Apparels Village Ltd. (11547)

Plot-37, Village:Khagan, Union Parishad: Birulia, Upozilla: Savar, Dist: Dhaka, Bangladesh

18.JUNE.2014

1st Priority 2 Concern

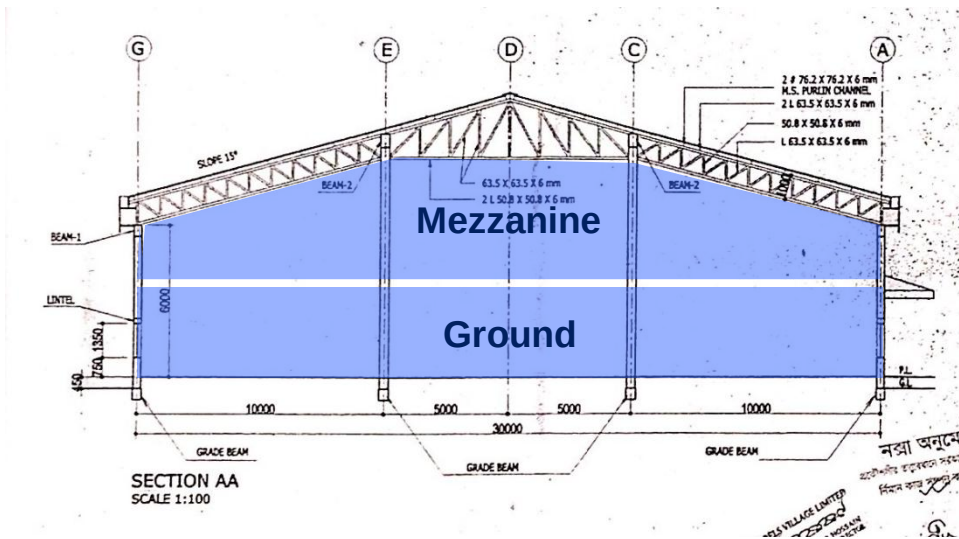
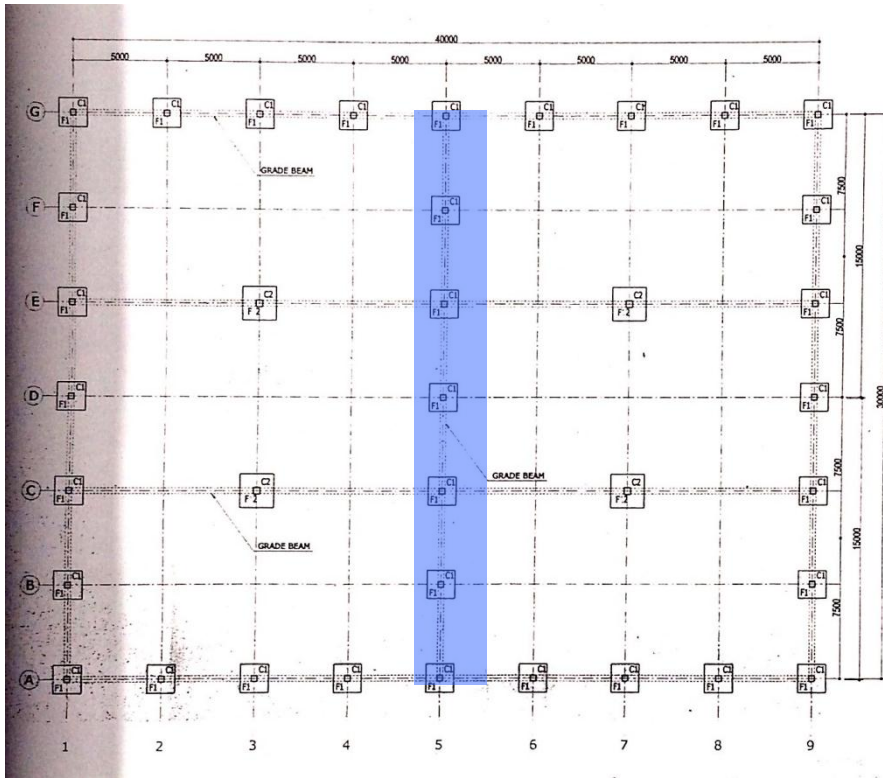
Cracks on beams and slab soffits of Building 1. The cause of cracks should be investigated by appropriate methods.

Item No.	Observation	Recommended Action Plan	Recommended Timeline
1	Priority 2 - Cracks on beams and slab soffits of Building 1.	The Factory Engineer to investigate the cause of cracks by appropriate methods. The distress found is to be suitably rectified and then repaired.	6-weeks
2	Priority 2 - Cracks on beams and slab soffits of Building 1.	Create loading plans for each floor level. Maintain standards of quality control to ensure that loading plan is correctly followed so that problems do not arise in the future. Maintain and enforce the loading plans.	6-months
3	Priority 2 - Inadequacies between the drawings of Shed 3 and the actual as-built conditions.	Factory Engineer to survey the actual conditions and revise the drawings. Any results of the DEA which affect the structure should be taken on board.	6-weeks
4	Priority 2 - Inadequacies between the drawings of Shed 3 and the actual as-built conditions.	Continue to implement load plan	6-months

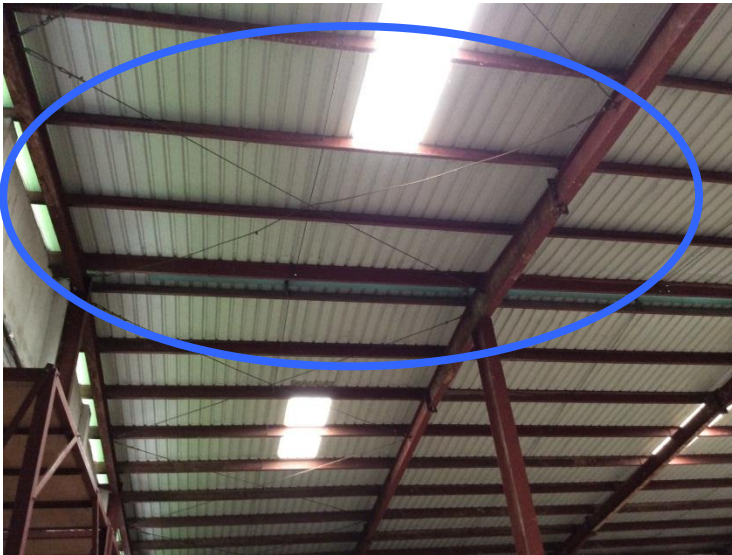
A mezzanine was added at the middle of Shed 3. This floor is used for offices and a laboratory. The drawings should be updated as early as possible.

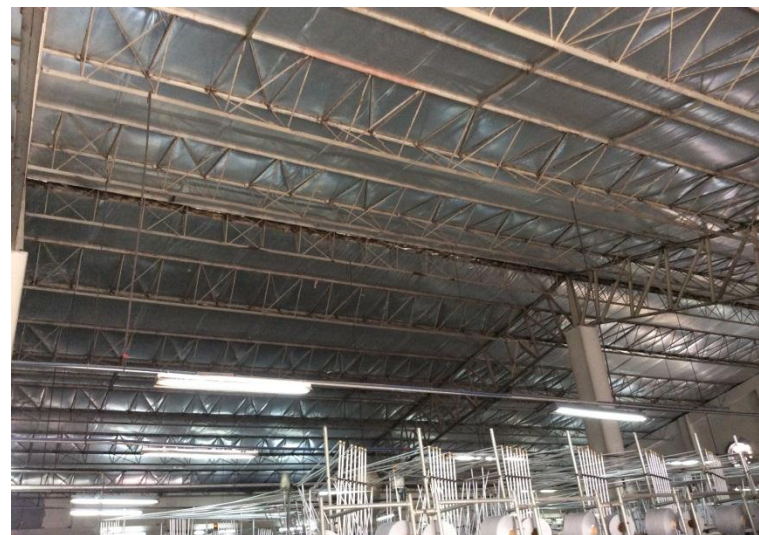
Guardrails were installed on inner side of Building 5. But there is no guardrail or parapet wall on outer side.

Item No.	Observation	Recommended Action Plan	Recommended Timeline
8	Priority 3 - Distress due to water ingress of Building 1 and Building 2.	Factory Engineer to inspect water damaged structures and repair with a suitable methods.	6-months
9	Priority 3 - No fireproofing material applied for structural steel elements of Shed 1, Shed 2, Shed 3, Shed 4 and Shed 5 (if required).	Fireproofing material for structural steel element is recommended as suggested in BNBC Codes.	6-weeks
10	Priority 3 - No fireproofing material applied for structural steel elements of Shed 1, Shed 2, Shed 3, Shed 4 and Shed 5 (if required).	Maintain standard of quality control and protection of the fire protection.	6-months
11	Priority 3 - No parapet wall or guardrail present at Building 5.	A suitable perimeter parapet wall or guardrail should be constructed along the building perimeter.	6-months
